From: Wickham, Jerry, Env. Health
Sent: Tuesday, January 17, 2012 2:42 PM
To: 'johnjay@jayphares.com'
Cc: Peter McIntyre; Jeremy A. Smith
Subject: RO2580: Site Management Plan
Attachments: Revised Figure 1 Impacted Area.pdf

We have received a preliminary draft of the Site Management Plan dated January 13, 2012 for planned construction activities near the former Young's Cleaners site. Prior to submitting the Site Management Plan we request the following:

**SITE PLAN WITH
 ESTIMATED IMPACTED AREA**

FIGURE 1
 PROJECT NO. 261829

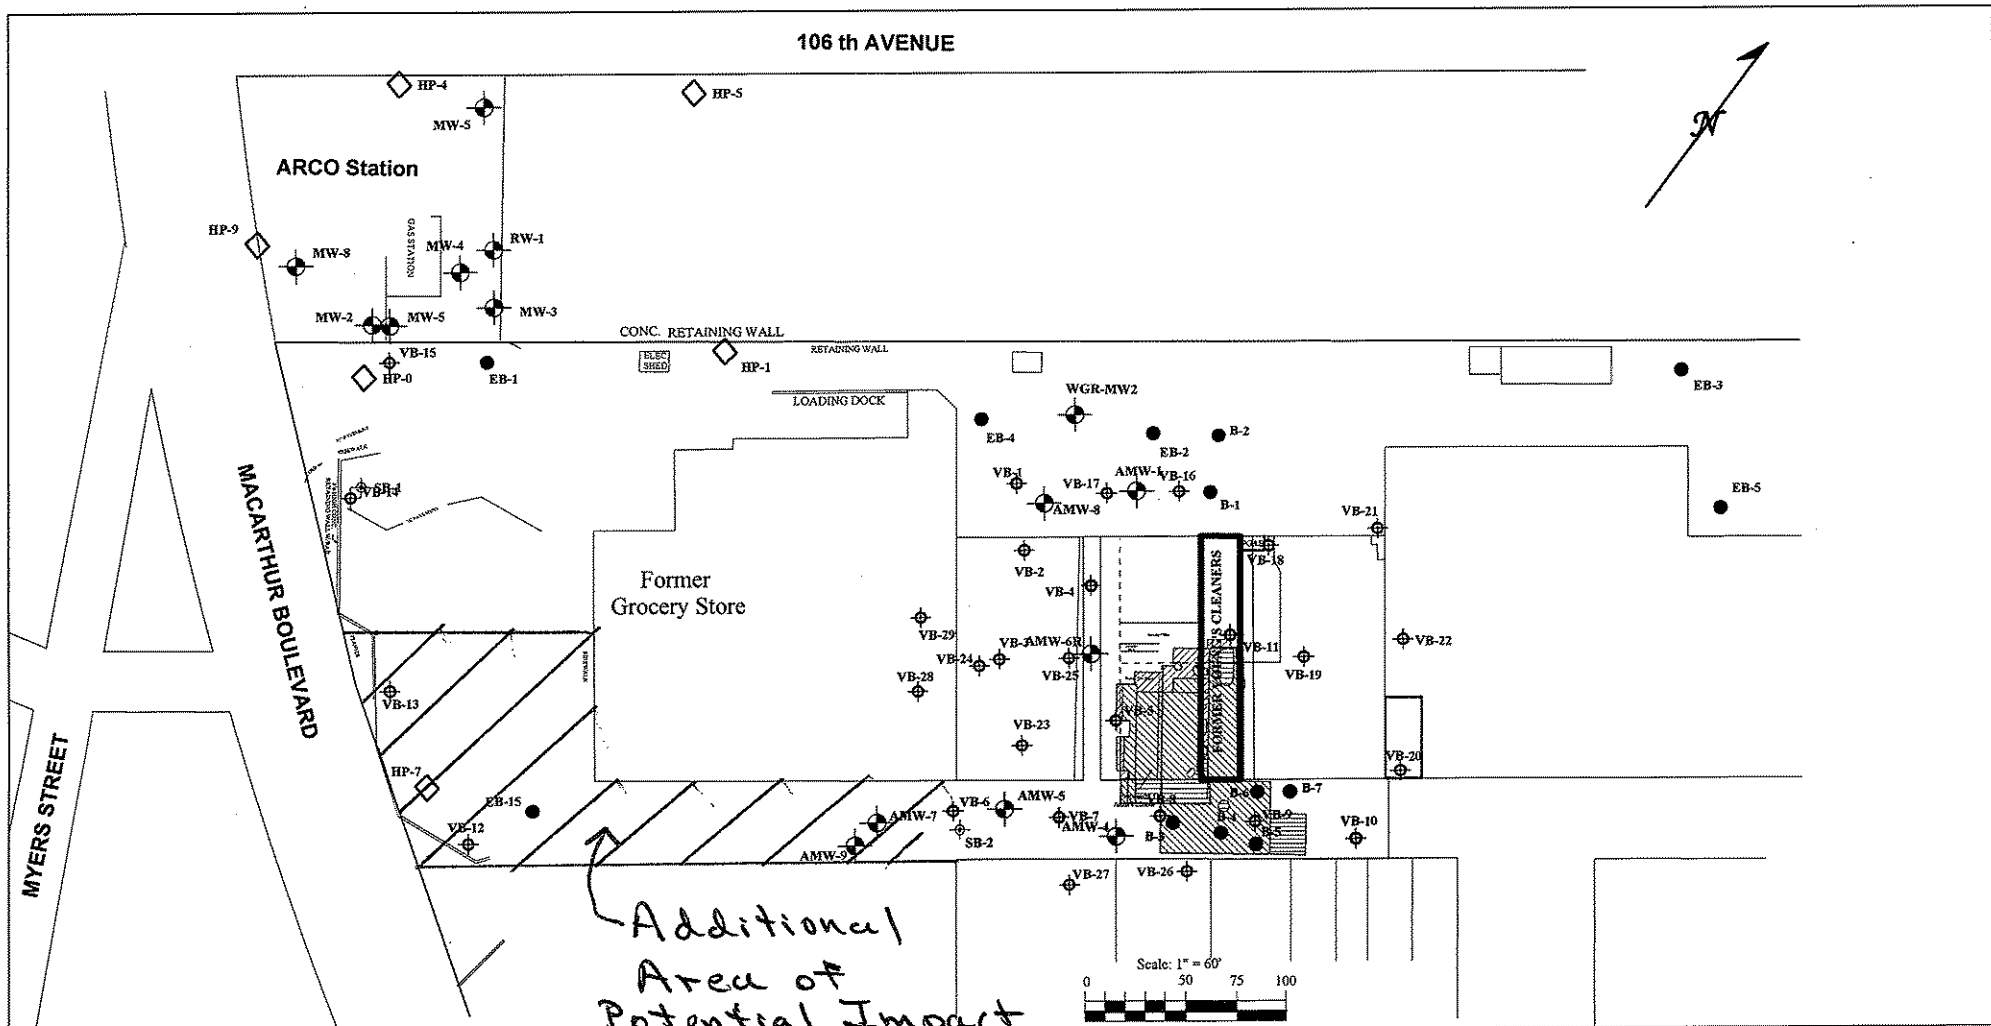
- 1) Please expand the "Estimated Extent of Potential HVOC Impact," to include additional areas to the west as shown on the attached map. Previous soil sampling at AMW-7 and AMW-9 indicates some VOC impact to soil. Soil vapor sampling results from VB-12 and VB-13 indicate potential impact in these areas as well.
